AGENDA
PLANNING BOARD
MEETING TIME 6:30 PM - MAIN MEETING ROOM
JANUARY 7, 2026

DATE: December 19, 2025
BOARD: Planning Board
APPLICATION: Christian Brothers Academy (#2025-206)
850 Newman Springs Road - Christian Brothers Academy
Block 1063, Lot 67.01
Minor Site Plan

Re: Varsity Gymnasium Air Conditioning
Christian Brothers Academy
850 Newman Springs Road
Block 1063, Lot 67.01
Minor Site Plan
First Engineering Review

MINOR SITE PLAN
CHRISTIAN BROTHERS ACADEMY
VARSITY GYM AIR CONDITIONING
LOT 67.01, BLOCK 1063, TAX MAP SHEET NO. 267, DATED 12/17/92
TOWNSHIP OF MIDDLETOWN
MONMOUTH COUNTY – NEW JERSEY

EXTERIOR PAD / HVAC UNIT LOCATION PLAN

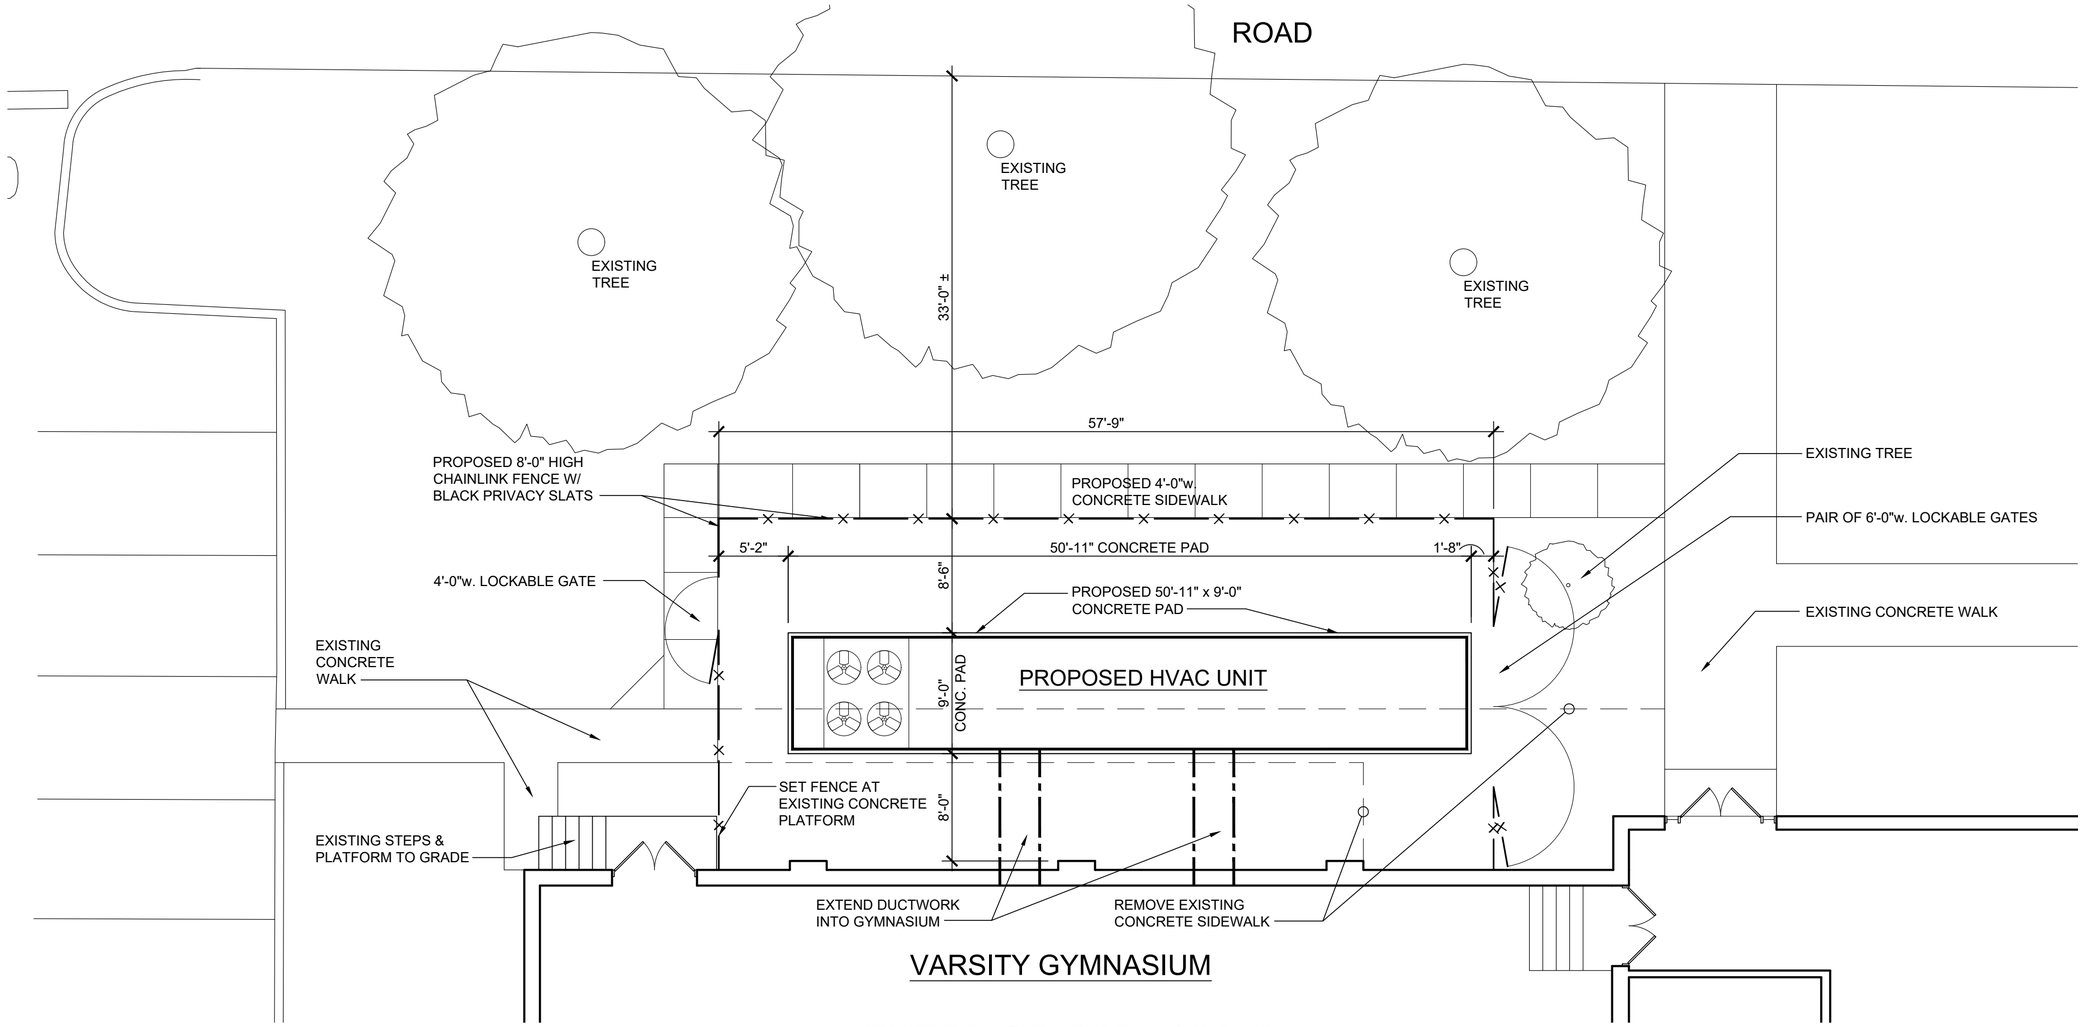
2. Minor Site Plan – The applicant proposes to install 481 sf HVAC system adjacent to the varsity gymnasium on top of a 458 sf concrete pad; enclose the system with an 8' tall chain-link fence with black privacy slats and with lockable gate access; and install a 4' wide concrete sidewalk around the perimeter of the concrete pad.

2. A construction detail shall be provided for the proposed fence.

3. We note that the existing sidewalk which is to be removed and relocated connects to the faculty parking lot to the east of the gymnasium. A note shall be added to the plans indicating that all improvements shall be in accordance with the current ADA regulations, where applicable.

4. Per Section 540-632.A.(1). of the Township Ordinance, screening of the HVAC unit shall consist of densely planted evergreen shrubs which shall grow to not less than five feet tall after one growing season. Currently no evergreen trees are proposed. The applicant shall provide the required screening or a design waiver will be required.

NORTH ELEVATION

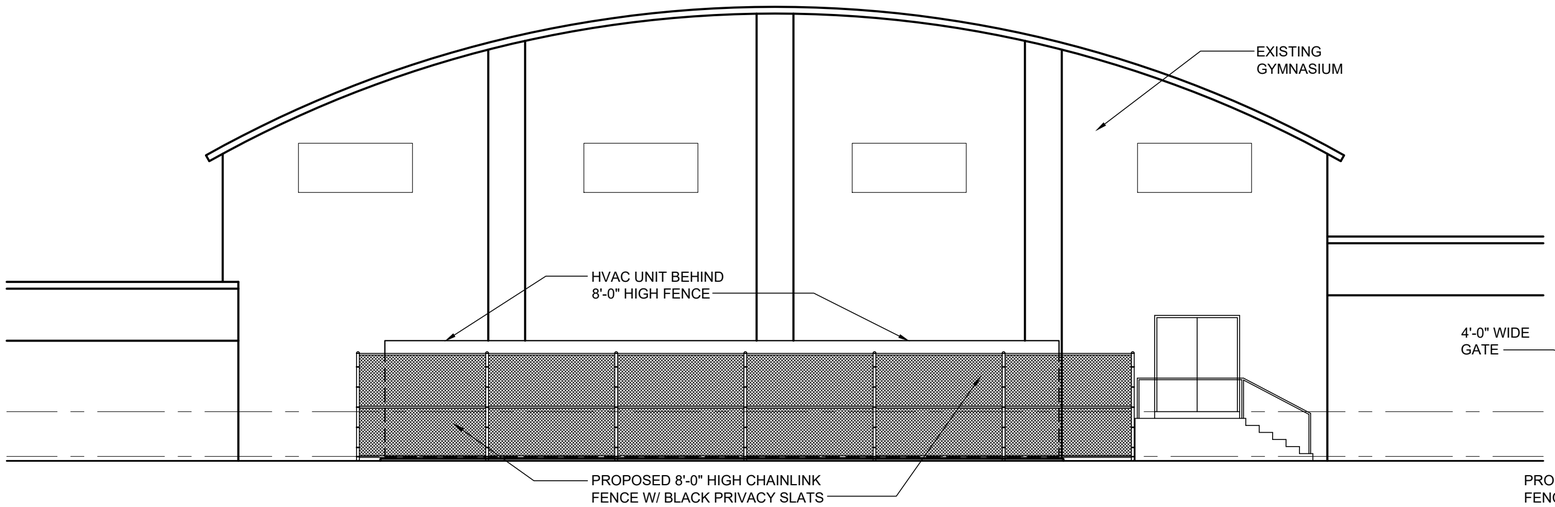
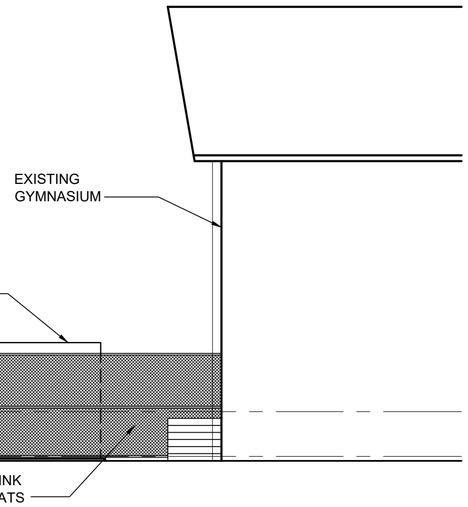
1. The applicant should clarify the height of the proposed HVAC unit. We note that as the unit is to be screened by an 8'-0" high chain link fence with privacy slats and the architectural elevation views indicate the unit will be slightly taller than the fence.
